## 00/300 AREA UNIT MANAGER MEETING

100/300 AREA UNIT MANAGERS MEETING  
APPROVAL OF MEETING MINUTES  
January 8, 2009

**Agreement:** Attachment 10 (narrative), Attachment 11 (excel table with proposed sampling changes), and Attachment 12 (maps showing location of sampling points in Attachment 11) are proposed changes to the *Remedial Investigation Work Plan for Hanford Site Releases to the Columbia River*, DOE/RL-2008-11, Rev. 0. RL, EPA, and Ecology approve the proposed changes as outlined in these three attachments.

Figure 2-11

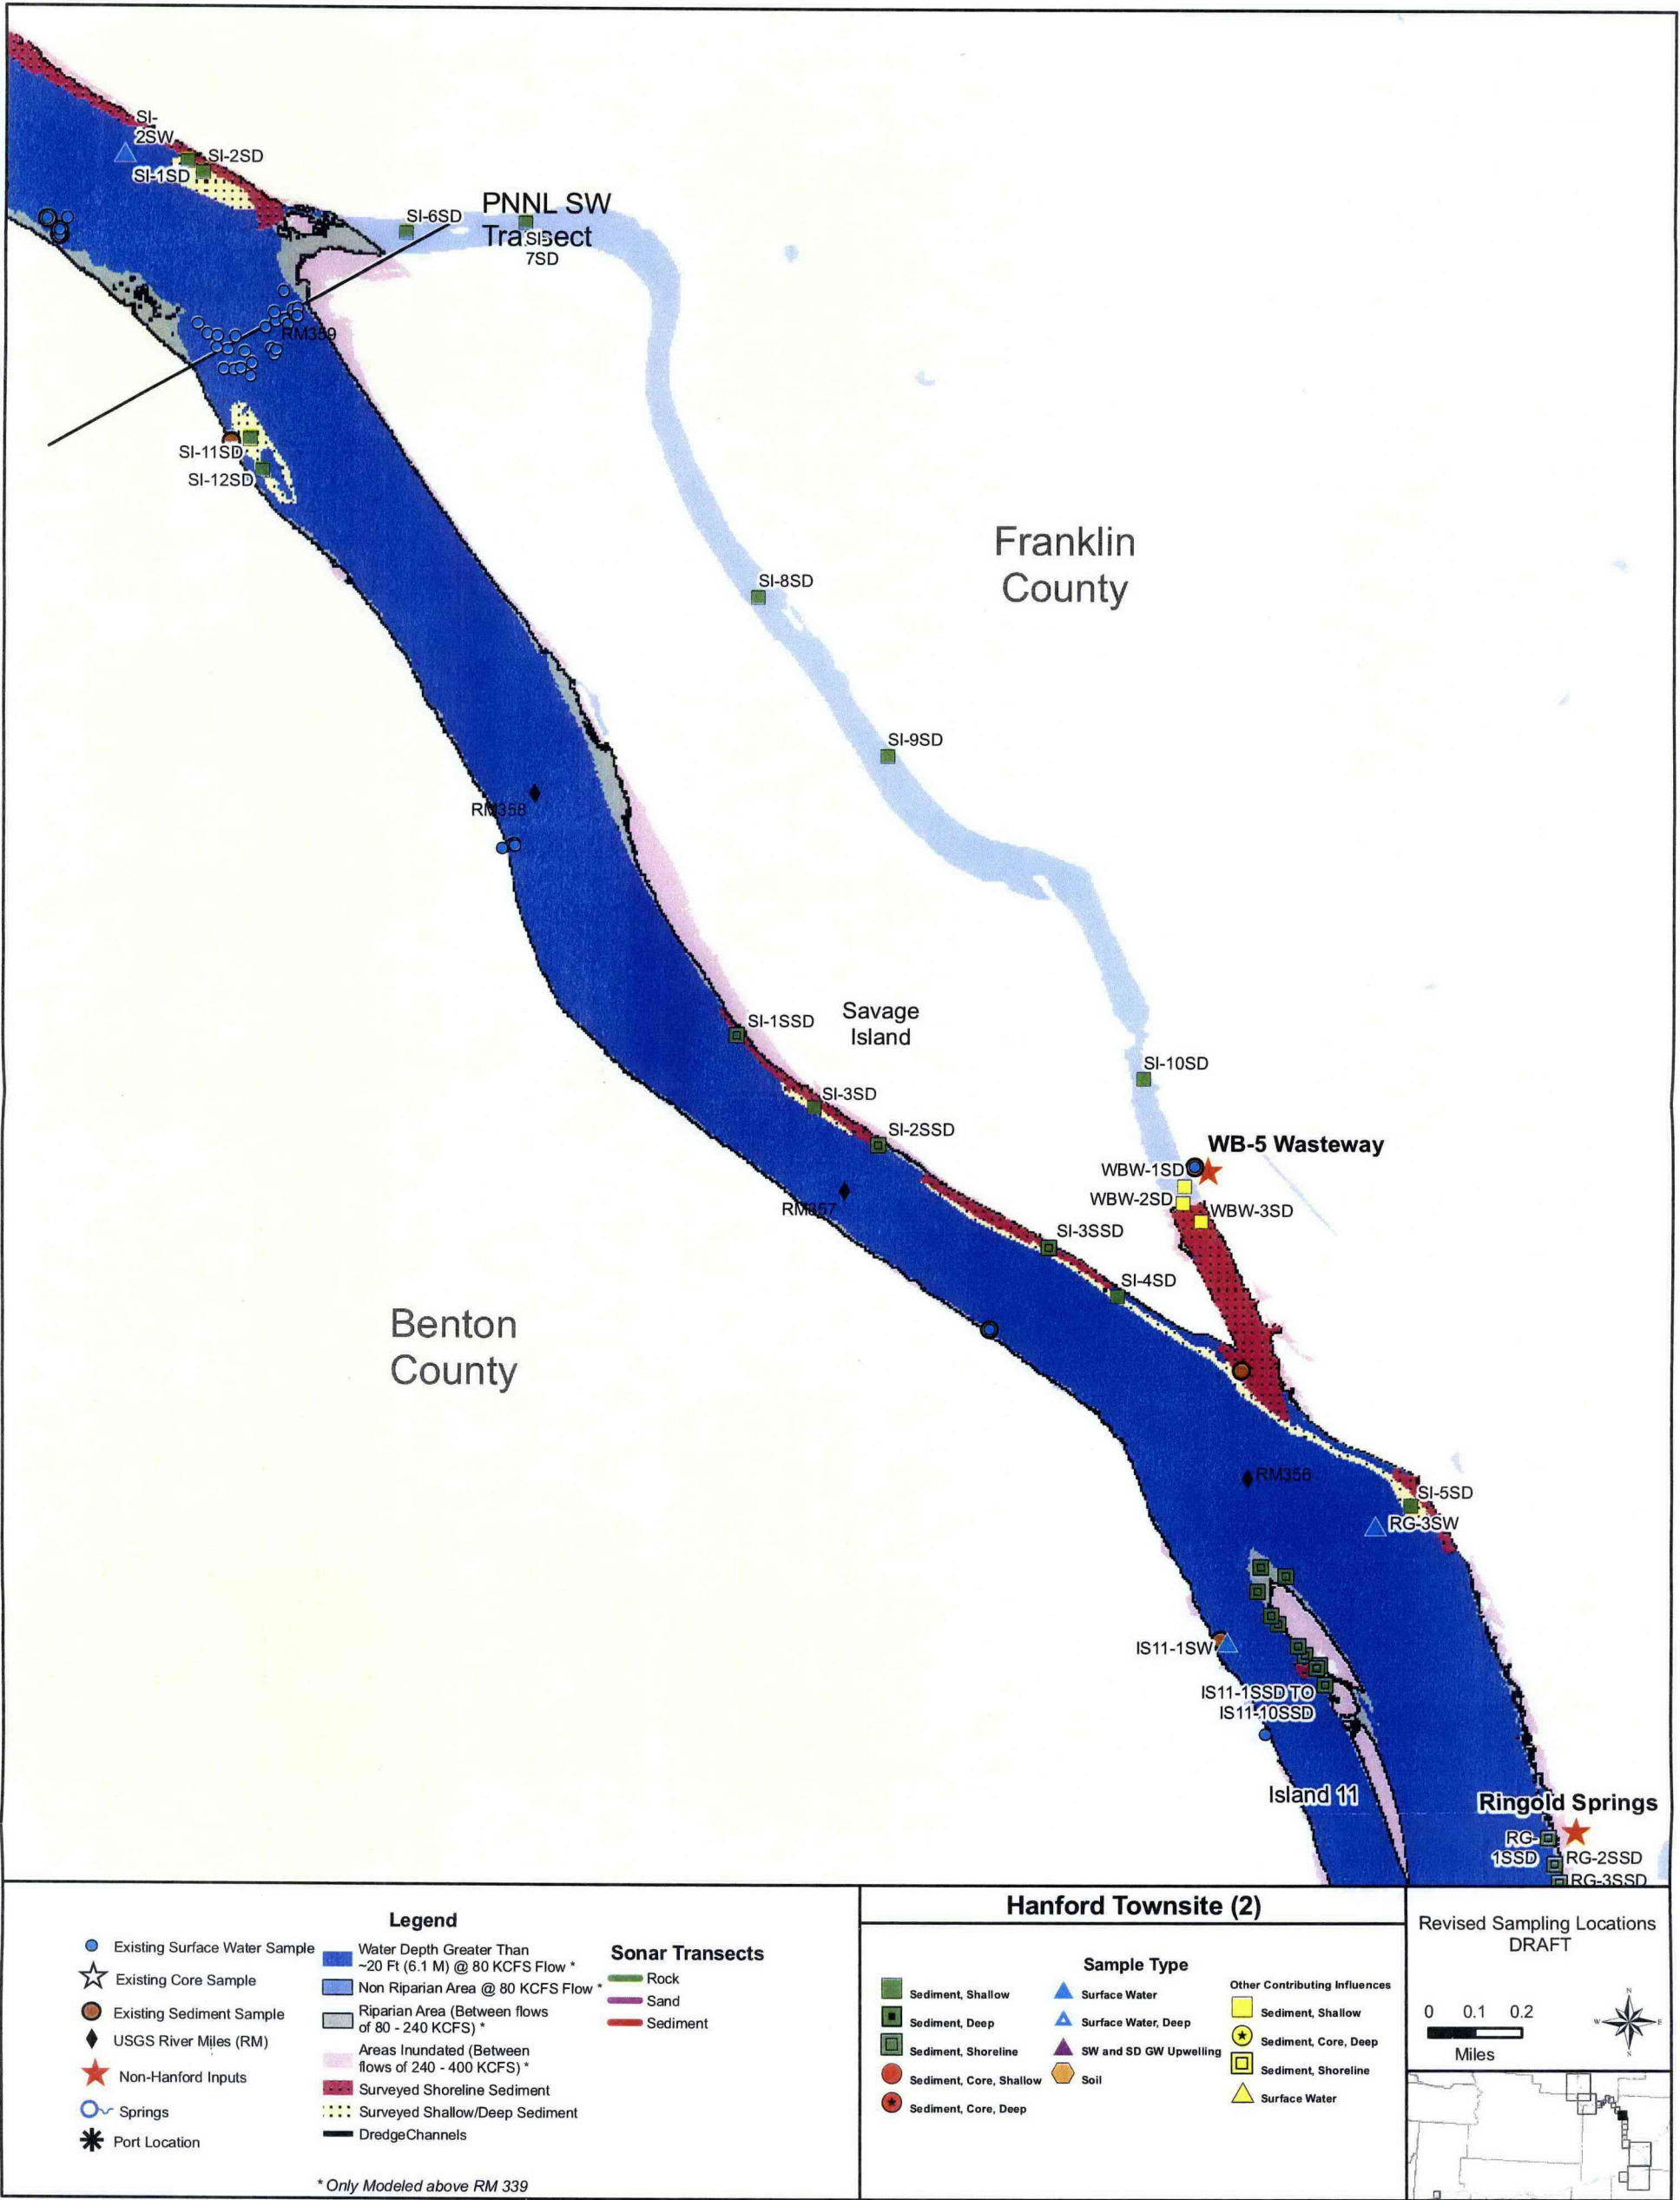
Sample Description														Rationale
Figure	Designation	Sample Type	Collection Method	Sampling Location	Temporary Sample ID	Adjustments	Confirmed Location	Eliminated		Add		Sample Design	Sample Depth	
								Notes	#	Notes	#			
Figure 2-11	HT	Sediment, Shallow	Ponar	Depositional Area top of Savage Island	SI-1SD to SI-5SD	Moved SI-3SD, 4SD, & 5SD lower on island	All	-	-	-	-	Random/Stratified	0 - 0.3 ft	Based on sonar survey results, five samples will be collected from the shallow area on the far (left) shore just upriver from river mile 359.
Figure 2-11	HT	Sediment, Shallow	Ponar	Savage Island	SI-6SD to SI-10SD	No survey done in this area, opportunistic	On-Site	-	-	-	-	Random/Stratified	0 - 0.3 ft	Five shallow sediment samples have been added behind Savage Island.
Figure 2-11	HT	Sediment, Shallow	Ponar	Right side across from head of Savage Island	SI-11SD to SI-12SD	New area of sediment identified	All	-	-	New Samples	2	Random/Stratified	0 - 0.3 ft	Two shallow sediment samples have been added across from head of Savage Island.

Figure 2-11	HT	Sediment, Shallow	Ponar	Island 11 Sediment	IS11-1SD to IS11-5SD	Eliminated; no sediment identified	-	All	5	-	-	Random/Stratified	0 - 0.3 ft	Based on sonar survey results, five samples will be collected from the shallow area from the downriver end of Island 11 across from Ringold Springs.
Figure 2-11	OCI	Sediment, Shallow	Ponar	WB-5 Wasteway	WBW-1SD to WBW-3SD	Opportunistic	On-Site	-	-	-	-	Focused	0 - 0.3 ft	Three samples will be collected from the shallow area on the far (left) shore just upriver from river mile 356 in the WB-5 Wasteway to evaluate other contributing influences.
Figure 2-11	OCI	Surface Water	Grab	WB-5 Wasteway	WBW-1SW (1 sample in spring, 1 sample in fall)	Opportunistic	On-Site	-	-	-	-	Focused	2/3 surface water depth	Two surface water samples will be taken (one each in spring and fall) at the WB-5 Wasteway to augment near shore RCBRA sampling and evaluate other contributing influences.

Figure 2-11	HT	Sediment, Shoreline	Grab	Ringold Recreational	RG-1SSD to RG-10SSD	New Samples	All	-	-	New Samples	10	Random/Stratified	0 - 0.3 ft	Ten new samples will be collected from shoreline sediment in the Ringold Recreational Area.
Figure 2-11	HT	Surface Water	Grab	Depositional Area top of Savage Island	SI-2SW	Limited	All	-	-	-	-	Random/Stratified	2/3 surface water depth	One surface water sample will be taken at the upriver end of Savage Island to augment near shore RCBRA sampling.
Figure 2-11	OCI	Surface Water	Grab	Island 11 Sloughs Surface Water	IS11-1SW	Limited	All	-	-	-	-	Random/Stratified	2/3 surface water depth	One surface water sample will be taken at the Island 11 Sloughs to augment near shore RCBRA sampling.
Figure 2-11	HT	Surface Water	Grab	Ringold Recreational	RG-3SW	Limited	All	-	-	-	-	Random/Stratified	2/3 surface water depth	One surface water sample will be taken between Ringold Springs and the WB-5 Wasteway to augment near shore RCBRA sampling.

Figure 2-15

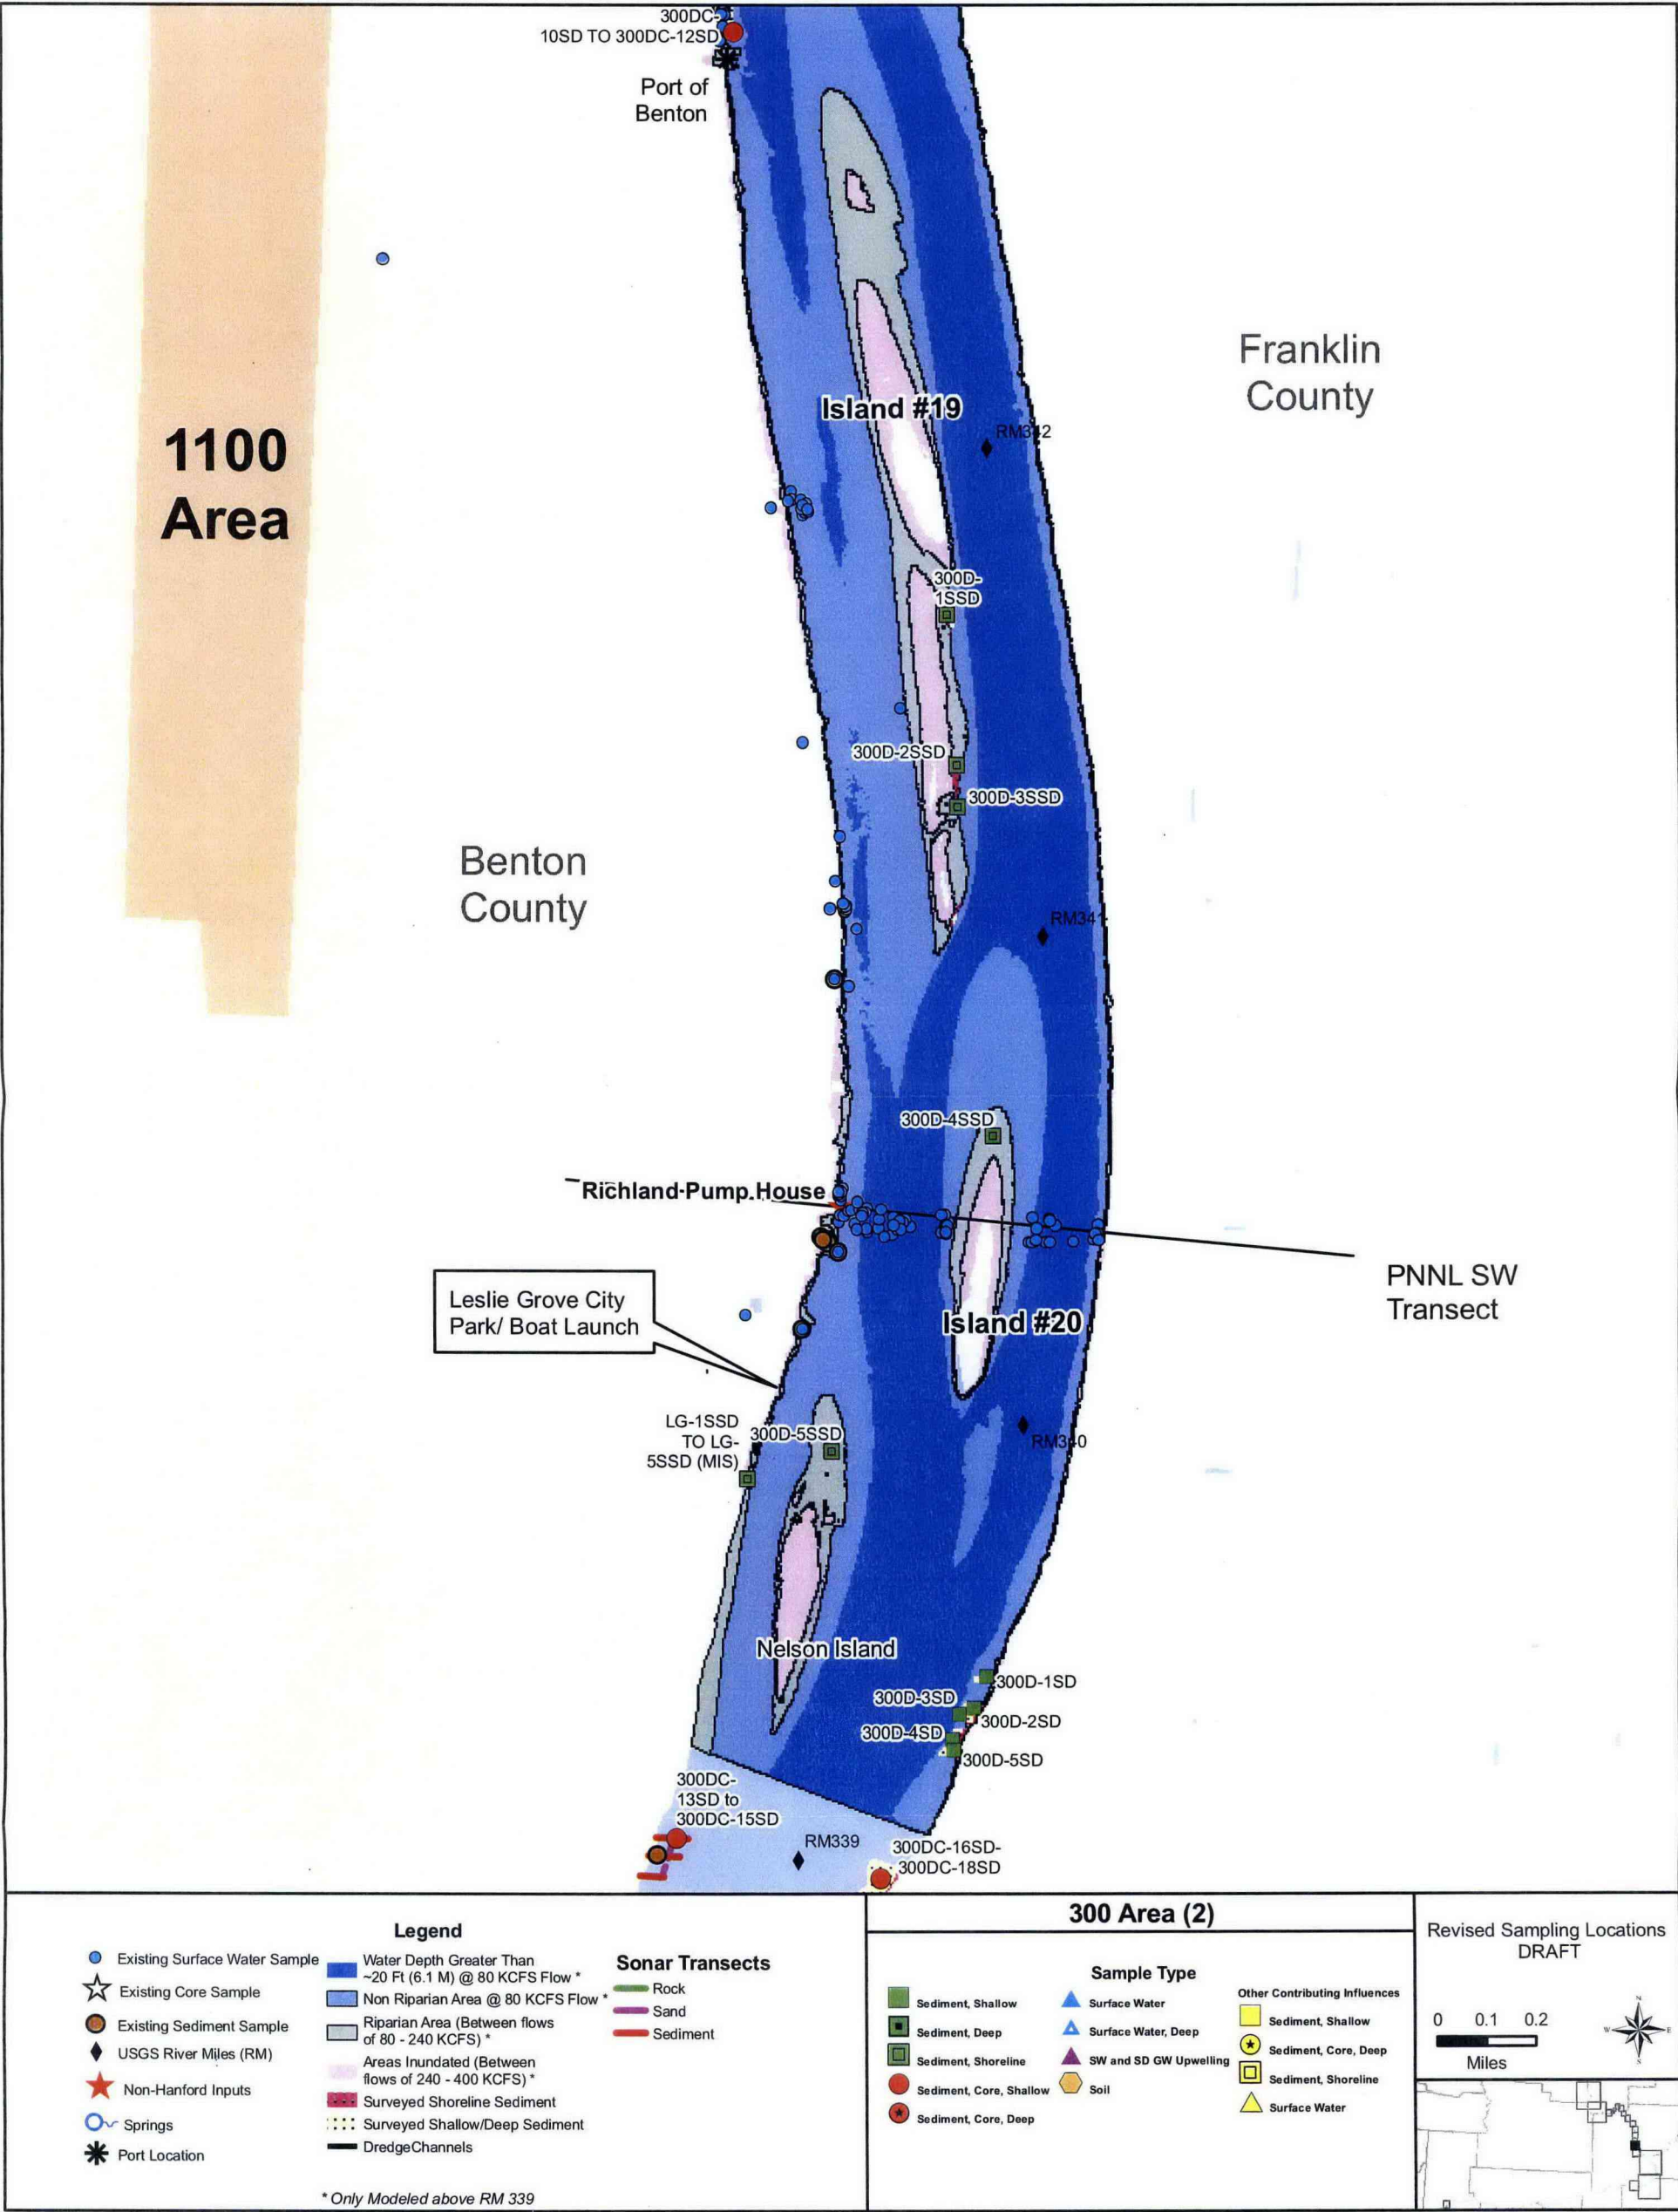
Figure 2-15	300 Area	Sediment, Shallow	Ponar	300 Area	300D-1SD to 300D-5SD	Limited sediment area; reduce to 5 samples	All	300D-6SSD to 10SSD	5	-	-	Random/Stratified	0 - 0.3 ft	Based on sonar survey results, samples will be collected from shallow areas near the far (left) shore just downriver from river mile 341.
Figure 2-15	300 Area	Sediment, Shoreline	Grab	300 Area downriver	300D-1SSD to 5SSD	Limited	All	-	-	300D-1SSD to 5SSD	5	Random/Stratified	0 - 0.3 ft	Based on an ecological habitat survey, five samples will be collected from the riparian area; two samples are from the upriver end of the Island at river mile 342; one sample is from the lower end of that island; one sample is from the upriver end of the island across from the Richland pump House; and the remaining sample is from the upriver end of Nelson island.
Figure 2-15	300 Area	Sediment, Shoreline	Grab	Leslie Grove City Park (5 replicate)	LG-1SSD to 5SSD	Limited shoreline sed near Leslie Grove; grid to be established in field	Have EAS check	-	-	-	-	MIS	0 - 0.5 ft	MIS samples will be collected from shoreline area of Leslie Grove City Park. These samples will be collected as 5 replicates.
